# Town of Hamburg Planning Board Public Hearing

**Site Plan Application**

**November 20, 2024**

**Applicant** Alliance Homes

# Updated Site Plan dated October 23<sup>rd</sup>:

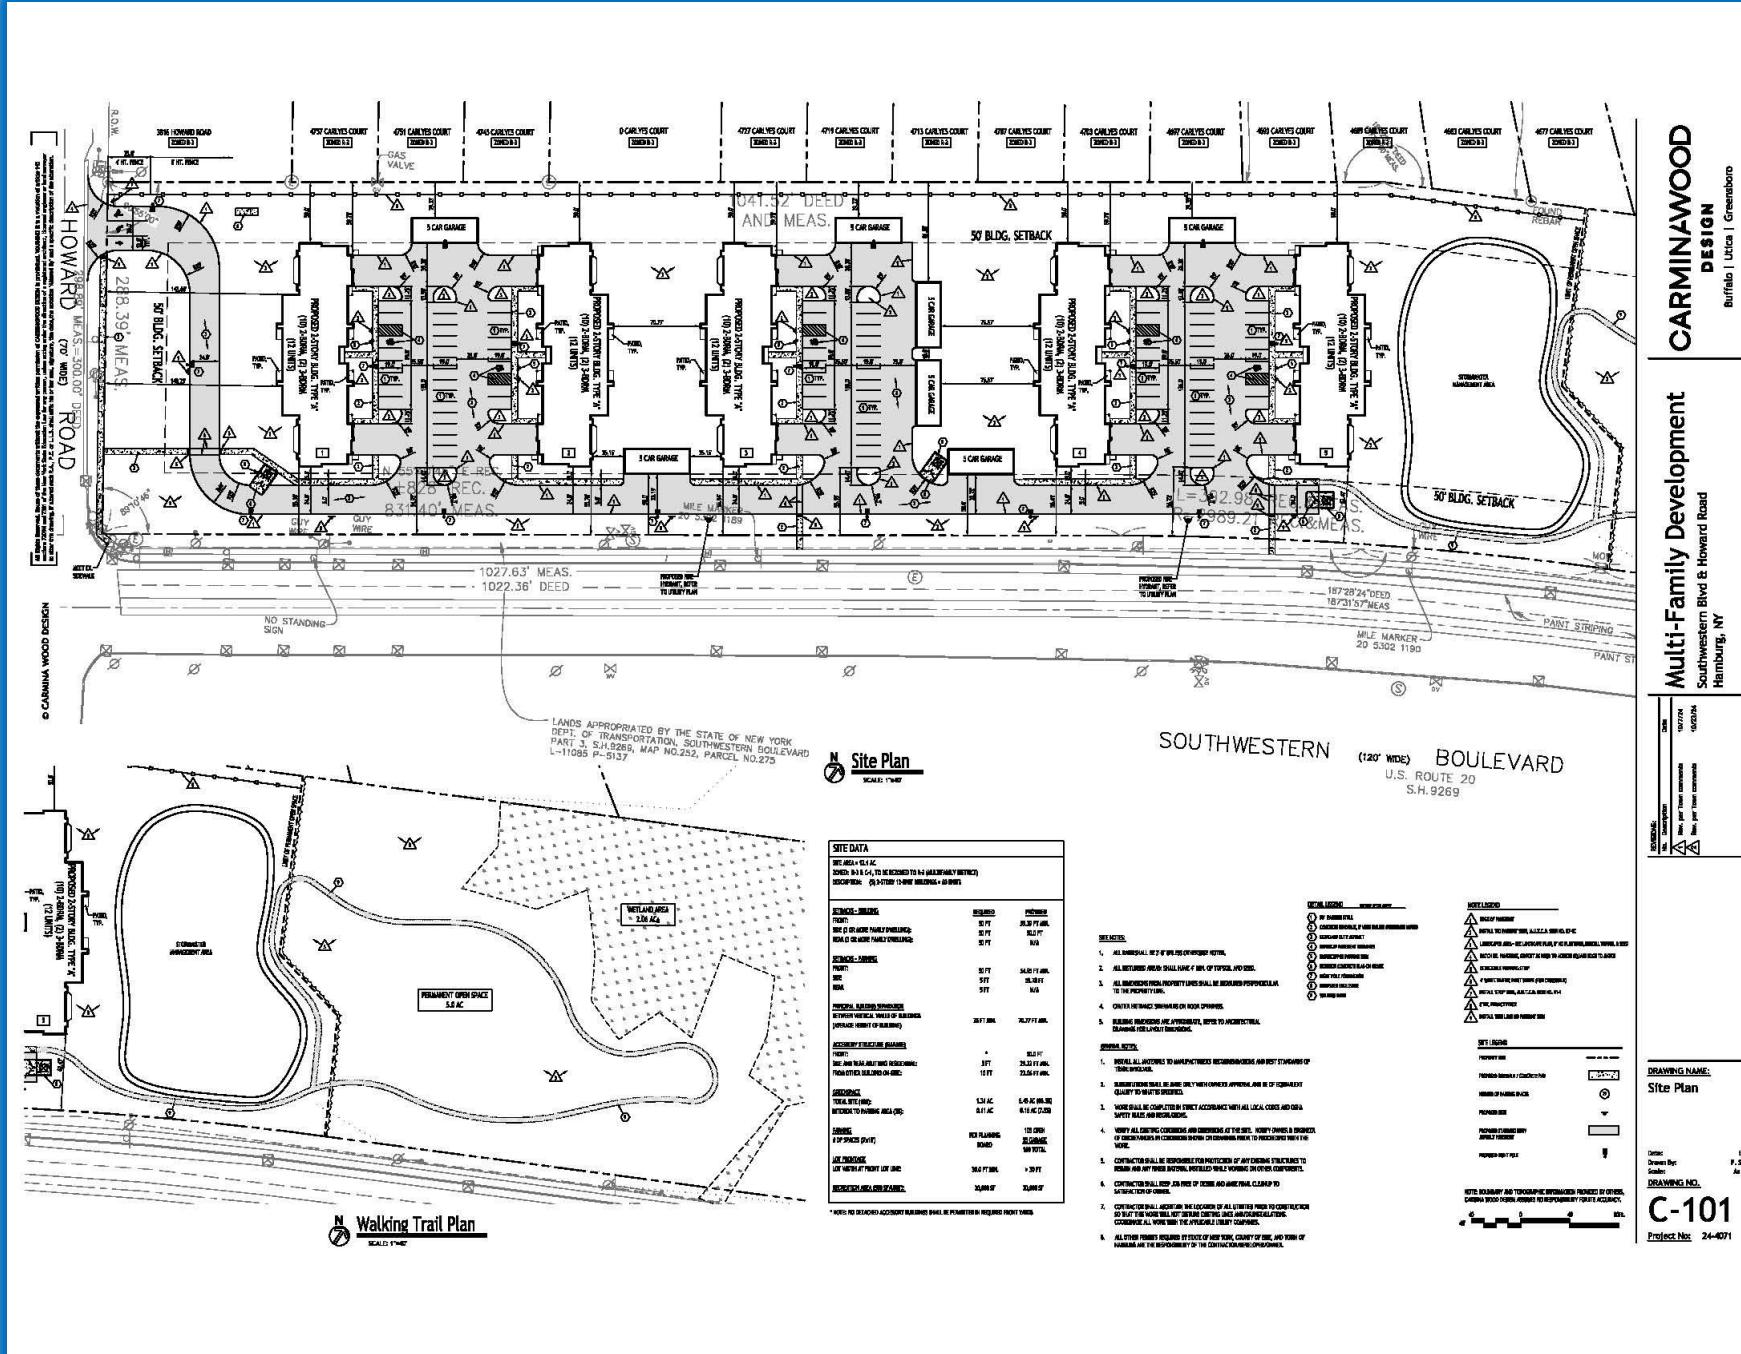
- 1. The previously proposed garage building located along the internal driveway onto Howard Road was removed based on the concern raised by the Planning Board regarding potential conflicts with vehicles entering and exiting the project.
- 2. A new five-foot wide public sidewalk has been added within the Howard Right-of-Way for the length of the Project Site
- 3. A sidewalk as depicted on the Site Plan [Drawing C-100] has been added along the north side of internal drive aisle that is parallel with Southwestern Boulevard with two sidewalk connections to the existing sidewalk located in the Southwestern Boulevard Right-of-Way.

# Updated Site Plan dated October 23<sup>rd</sup>:

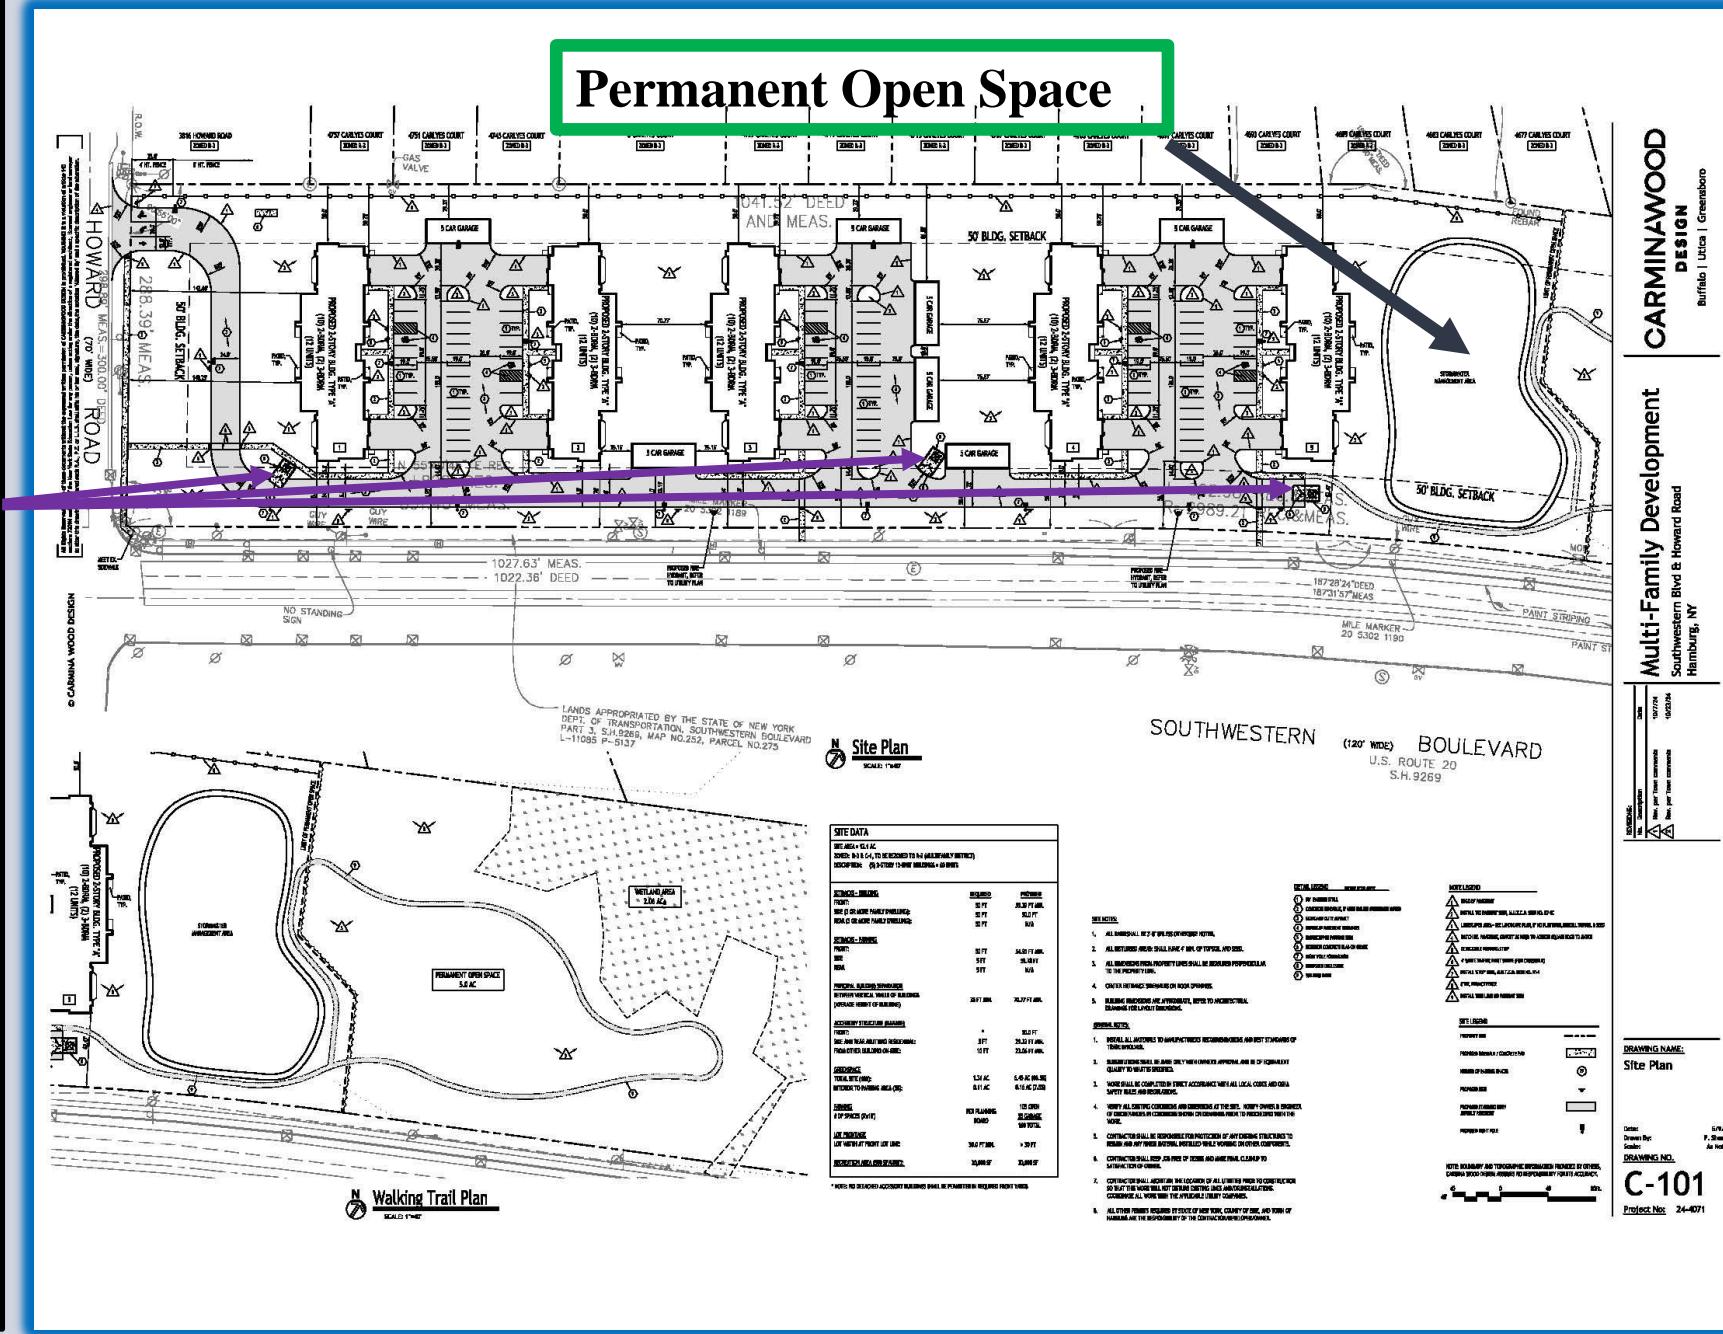
- 4. The driveway connection to Howard Road has been modified to include two (2) exiting lanes.
- 5. The three enclosed dumpsters were relocated from the rear site of the Project Site to the front side of the Project Site as requested by the Planning Board. Additionally, the dumpsters will also be screened with landscaping as depicted on the updated Landscape Plans [Drawings L-101, L-102 & L-103].
- 6. Truck Turn Plan [Drawing T-100] prepared to demonstrate that the project layout complies with the emergency access standards per Appendix D of the NYS Fire Code.
- 7. Location of the two proposed private fire hydrants added that will provide coverage for buildings within the 400 ft. requirement.

# Updated Site Plan Submission dated November 9<sup>th</sup>

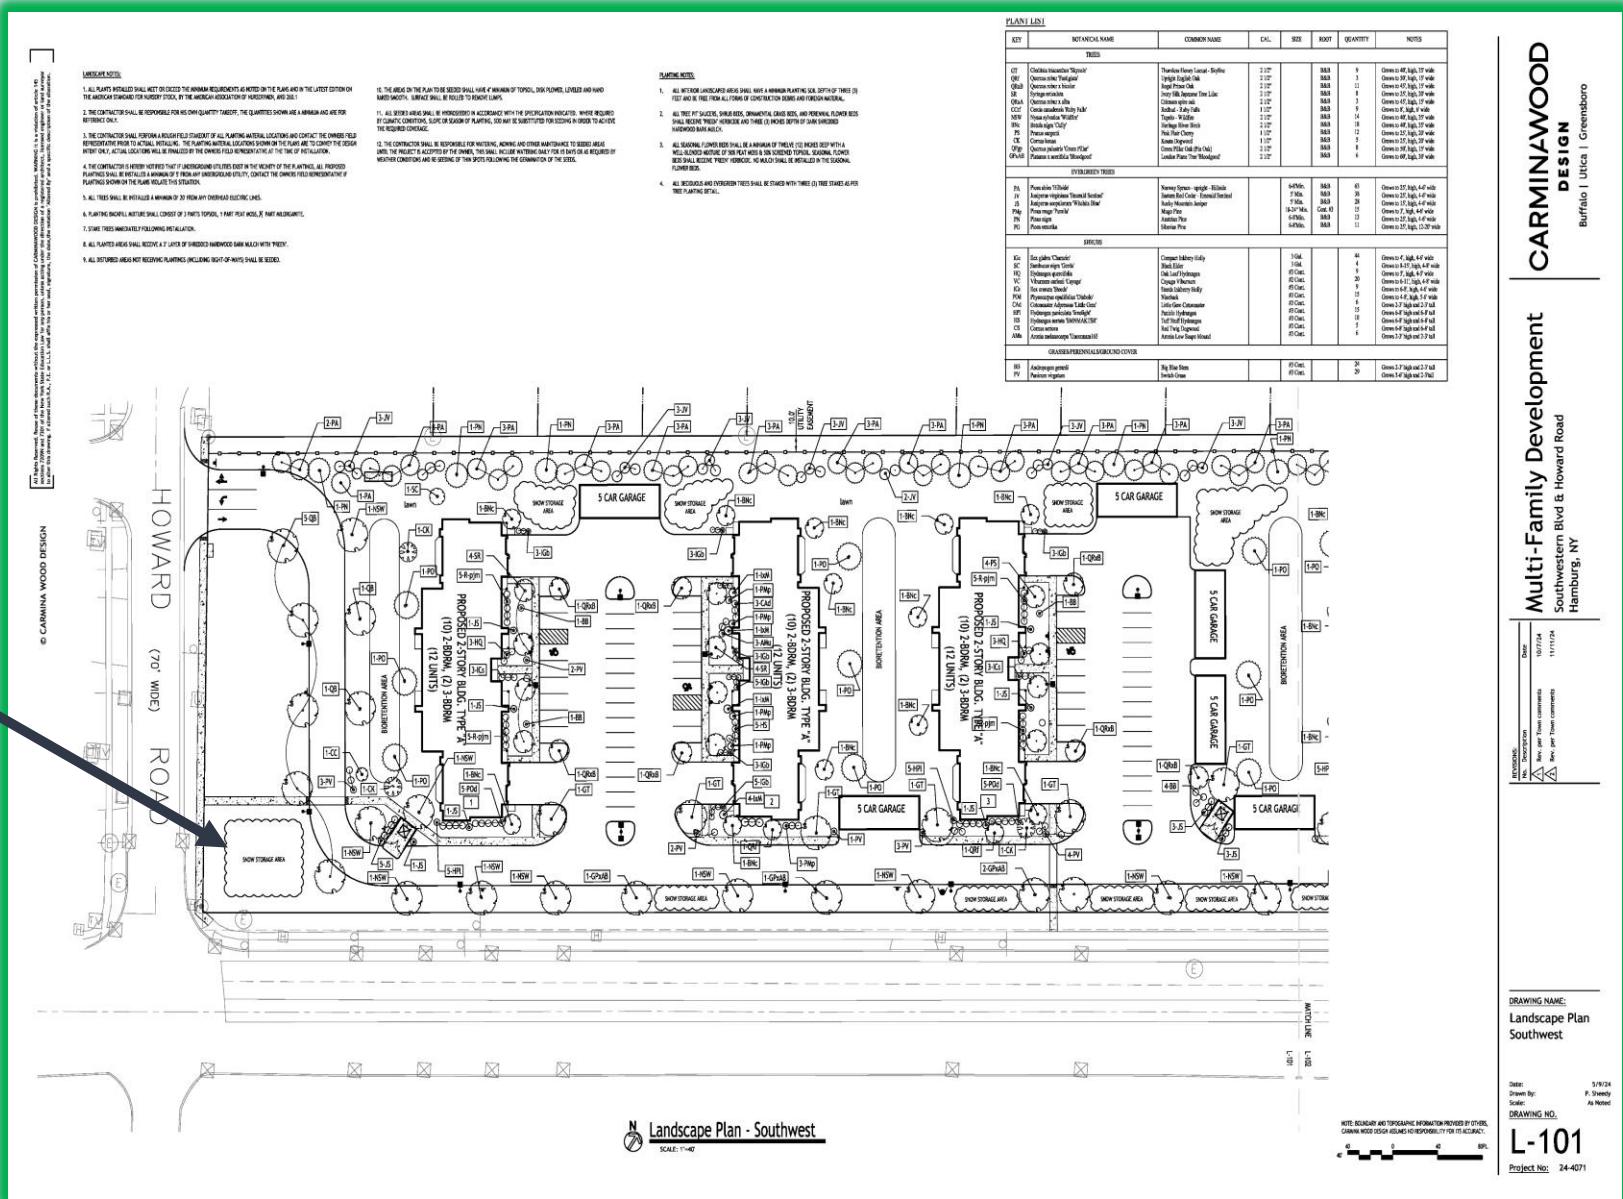
- **Responses to Planning Board Comments:**
- **Comment No. 1:** Show snow storage areas on the Landscape Plan.
- **Response:** 12 snow storage areas have been added to the updated Landscape Plans as requested.

# Updated Site Plan Submission dated November 9<sup>th</sup>

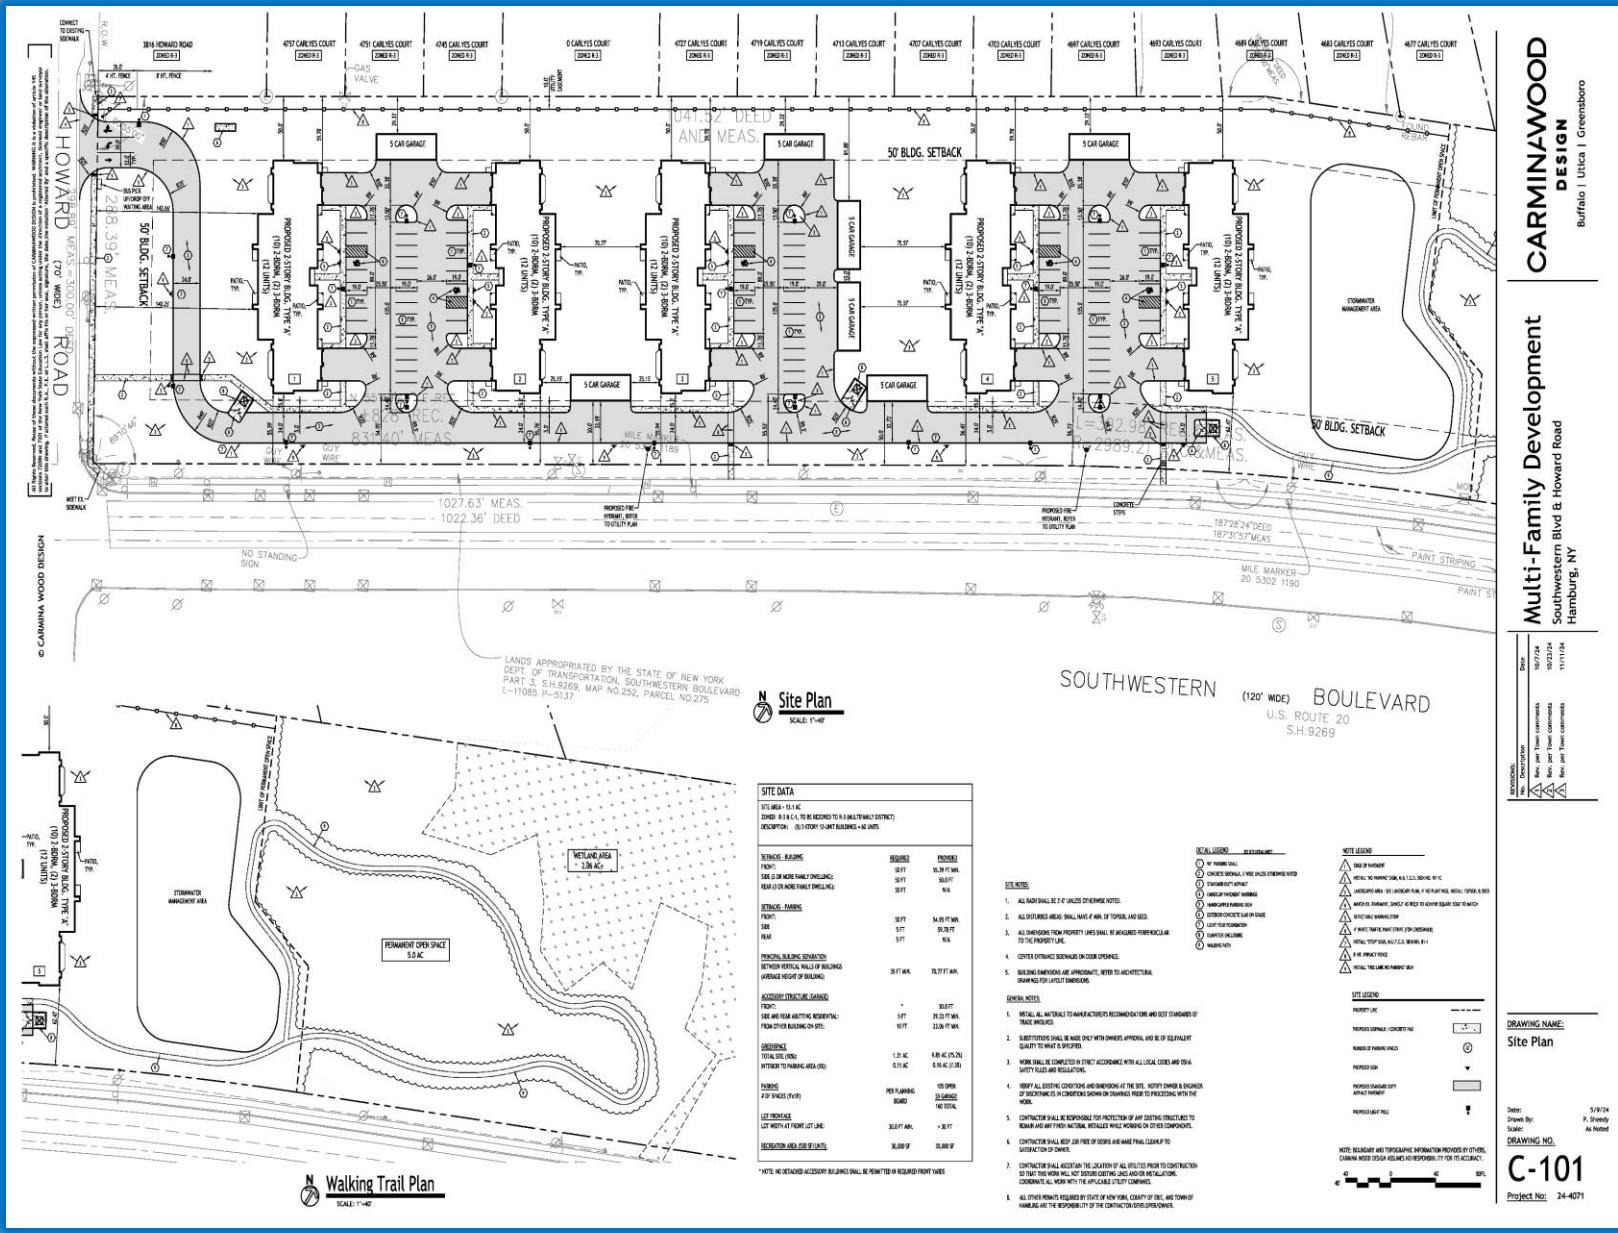
- **Comment No. 2:** Show school bus pick up and drop off area near Howard Road driveway.
- **Response:** A 4 ft. by 8 ft. bus stop pick up/drop off area has been added adjacent to the western side driveway connection on Howard connected to the proposed public sidewalk extension along Howard on the Site Plan Drawings.
- **Comment No. 3:** Extend sidewalk on Howard to the western boundary of the project site.
- **Response:** The sidewalk has been extended to the western boundary as shown on the updated Site Plan Drawings.

**E-MAIL FROM CHRIS HULL (BIG TREE  
VFC CHIEF) DATED OCTOBER 1, 2024:**

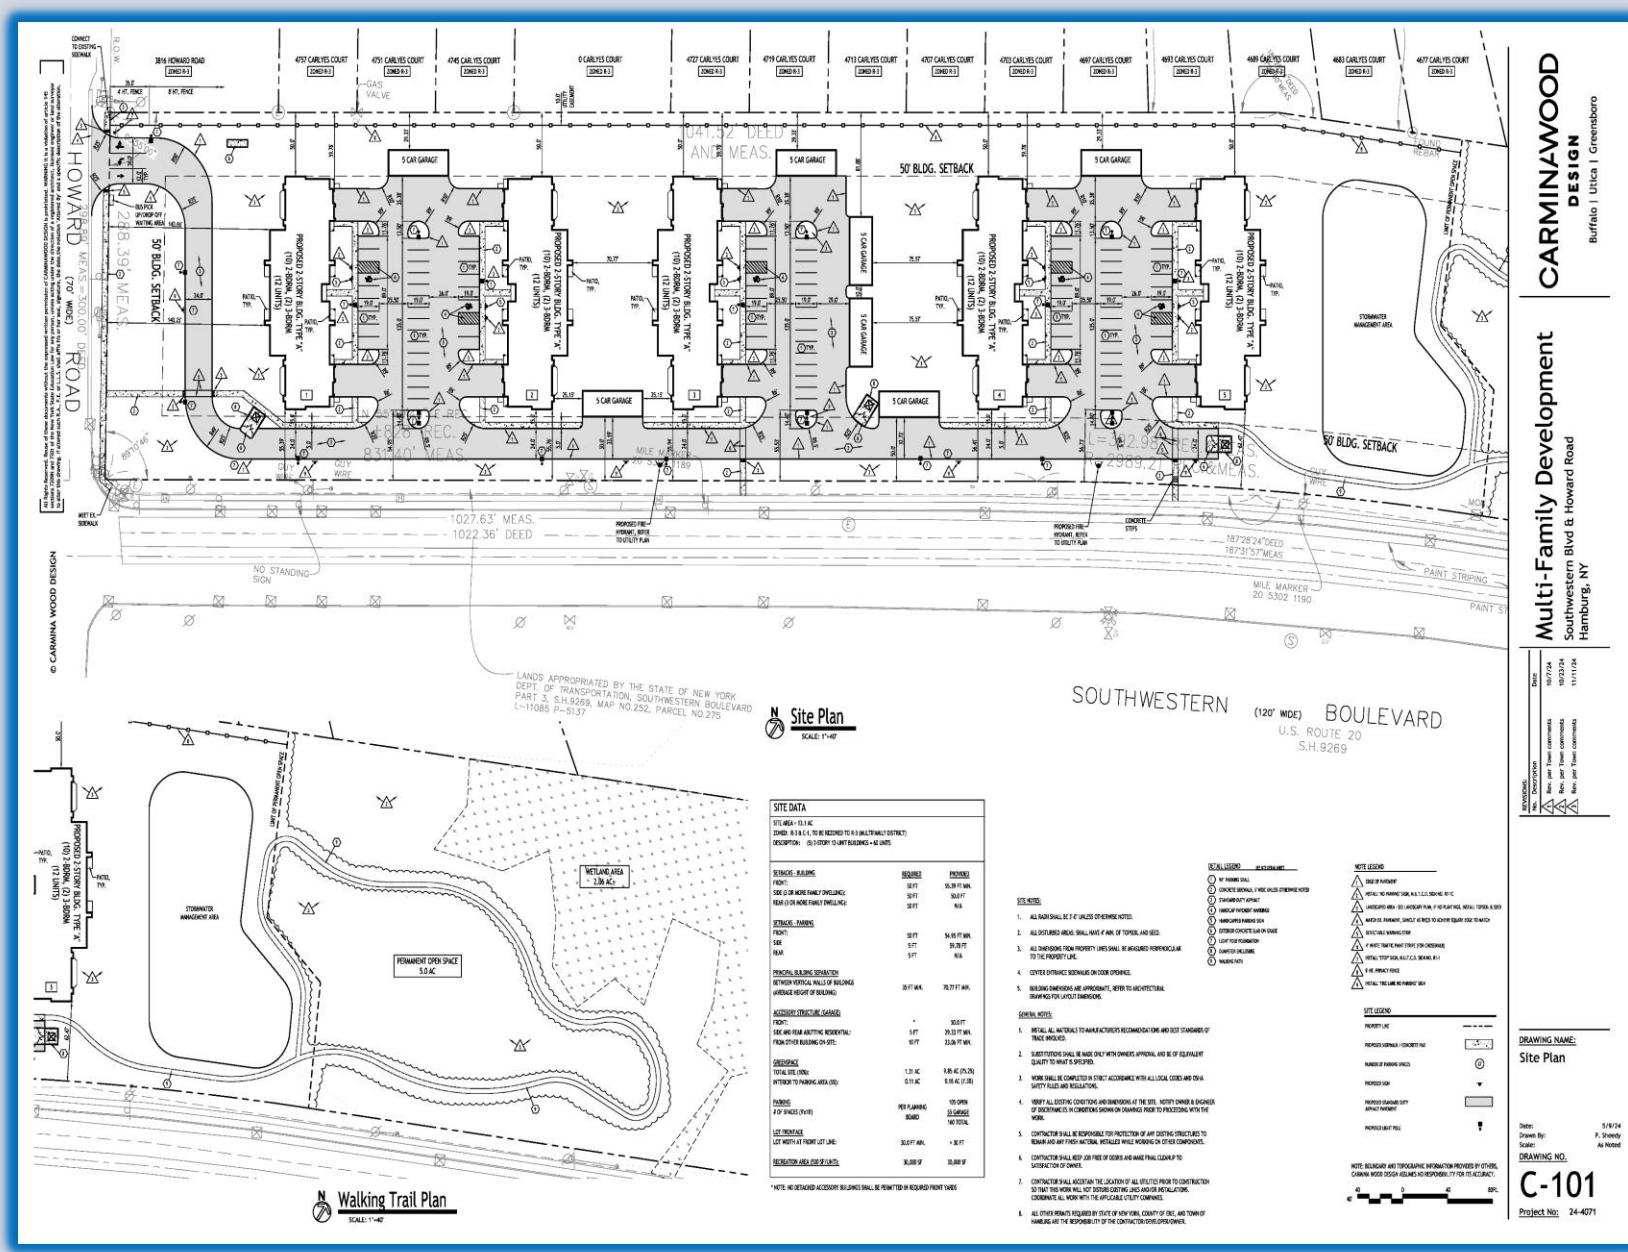
- Comment No. 1:** We are unable to note any additional hydrants for this project. Please provide hydrant placement(s). If none are added then a request would be to add a hydrant on at least a 12-inch main located near the third building on the Southwestern side of the access road.

- Comment No. 2:** We are also requesting enough room to be able to make the turns in each apartment build lot for our apparatus.
- Response:** A fire truck turning plan was previously submitted on October 9<sup>th</sup>.

- Response:** Two private fire hydrants were previously added to the Site Plan drawings on October 9<sup>th</sup> as previously submitted to the Planning Department. The proposed waterline service will be an 8" service, this size is adequate to serve the proposed buildings and private hydrants. Any larger diameter size waterline is not typical for residential or multi-family developments and typically used for transmission lines and not service lines.
